# Brookline Preservation Commission

## Local Historic District Report

Address: 195 Babcock Street  
District: Graffam-McKay LHD  
Owner: James Miczek  
Date Built: 1897-1898  
Architect: James Murray  
Builder: A.E. Coffin

View of the generator from Babcock Street

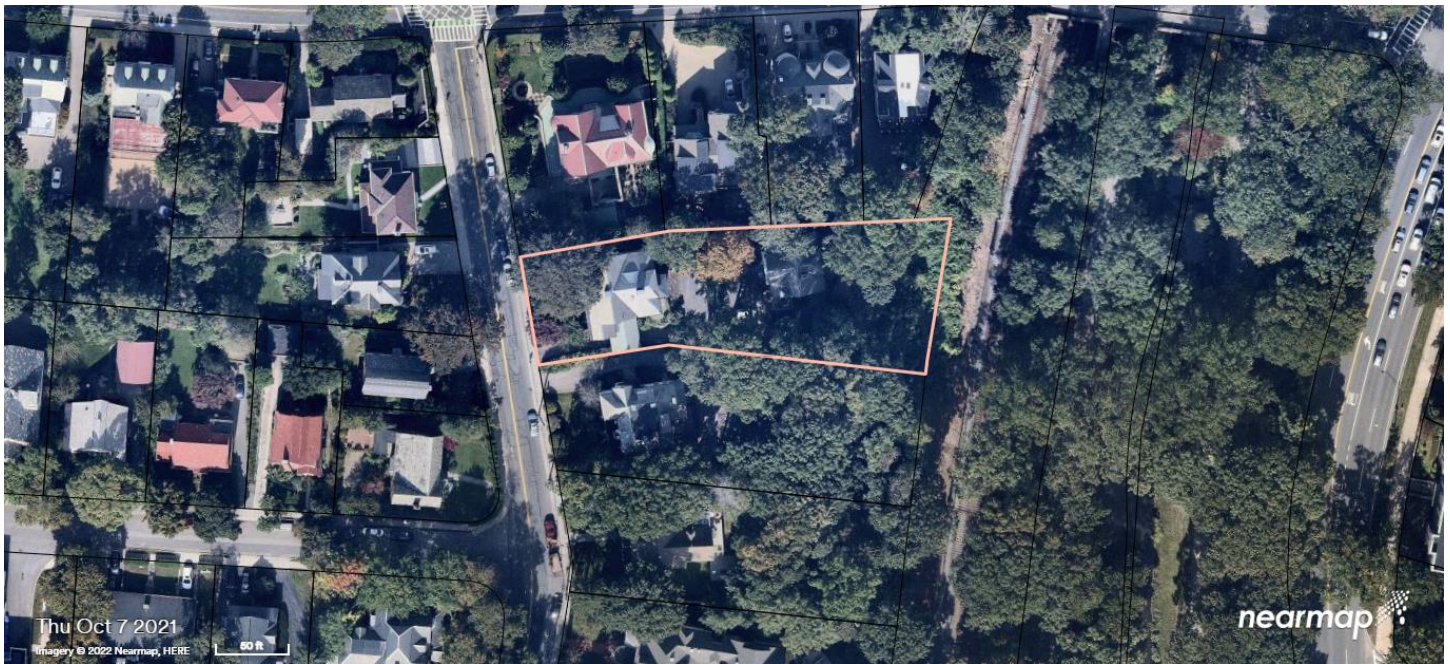
The location of the installed generator is not considered appropriate under the design guidelines. The applicant argued that the placement of the generator should be approved due to the need for it to be easily accessed by a person in a wheelchair and for maintenance purposes. Regardless of its location, the generator should be screened with appropriate screening, as stated in the design guidelines. Staff requested that the applicant include a suitable screening plan as part of his application but has not yet received this information.

- While landscaping is generally not subject to review by the Commission, the following are subject to review and approval by the Commission: (iii) outside HVAC equipment, condensers, and PVC venting pipes (all of these should be located in the rear, if possible) and have some kind of screening
